RENESAS TECHNICAL UPDATE

Product Category	MPU/MCU		Document No.	TN-RZ*-A0113A/E	Rev.	1.00
Title	RZ/G1H, G1M, G1N and G1E Correction of section 15. External Bus Controller for DDR3-SDRAM (DBSC3)		Information Category	Technical Notification		
Applicable Product	RZ/G Series, RZ/G1H, RZ/G1M, RZ/G1N, RZ/G1E	Lot No.	Reference Document	RZ/G Series, User's Manual: Hardware Rev.1.00 (R01UH0543EJ0100)		
		All lots

Document correction for section 15. External Bus Controller for DDR3-SDRAM (DBSC3).

Figure 15.29 M0(/1)RESET# pin level during DDR power-up

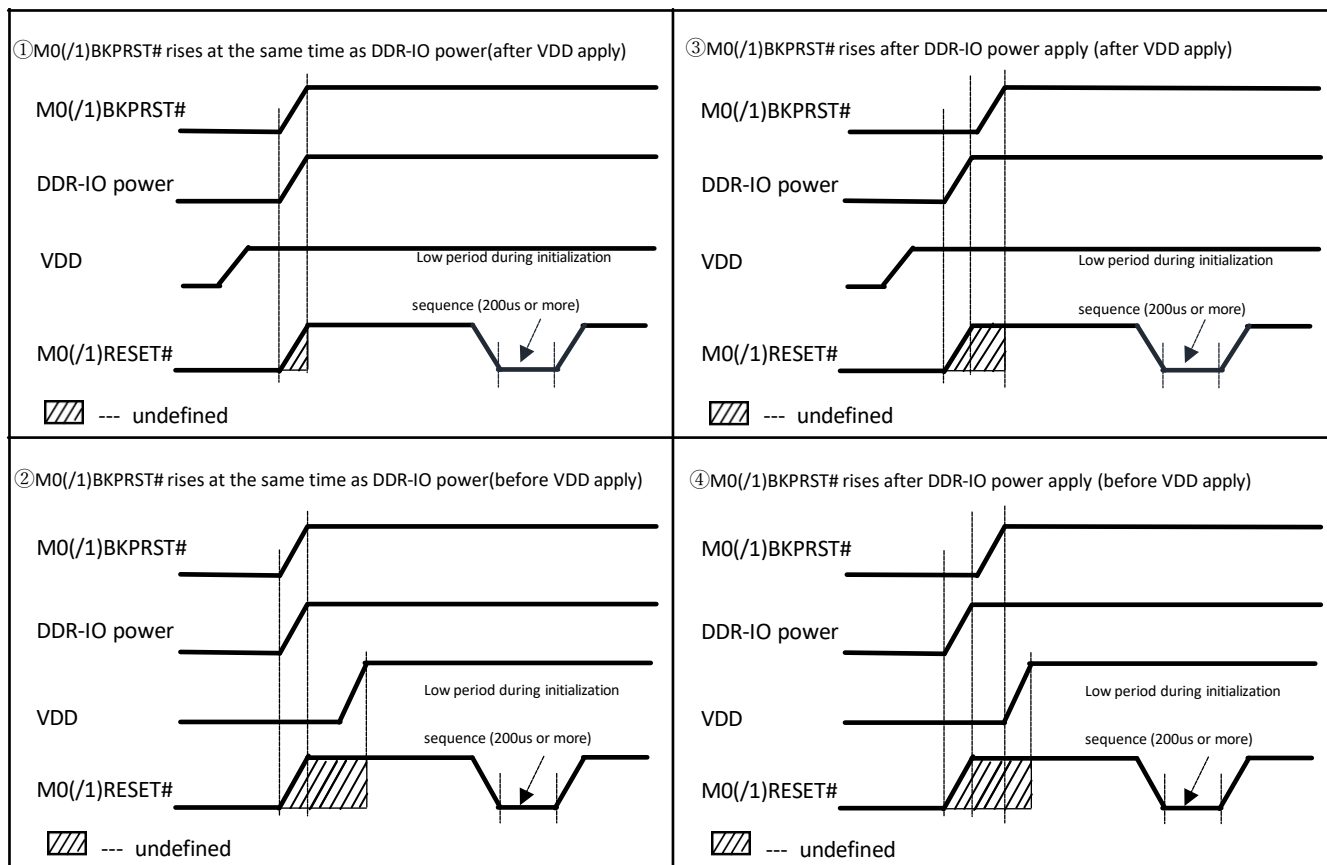
1. Section 15.8 M0(/1) RESET# pin level during DDR power-up, new section is added.

The pin level of M0(/1)RESET# is undefined during DDR power-up as shown in Figure 15.29

Caution for M0(/1)RESET# pin level during DDR power-up.

15.9 M0(/1)RESET# pin level during DDR power-up
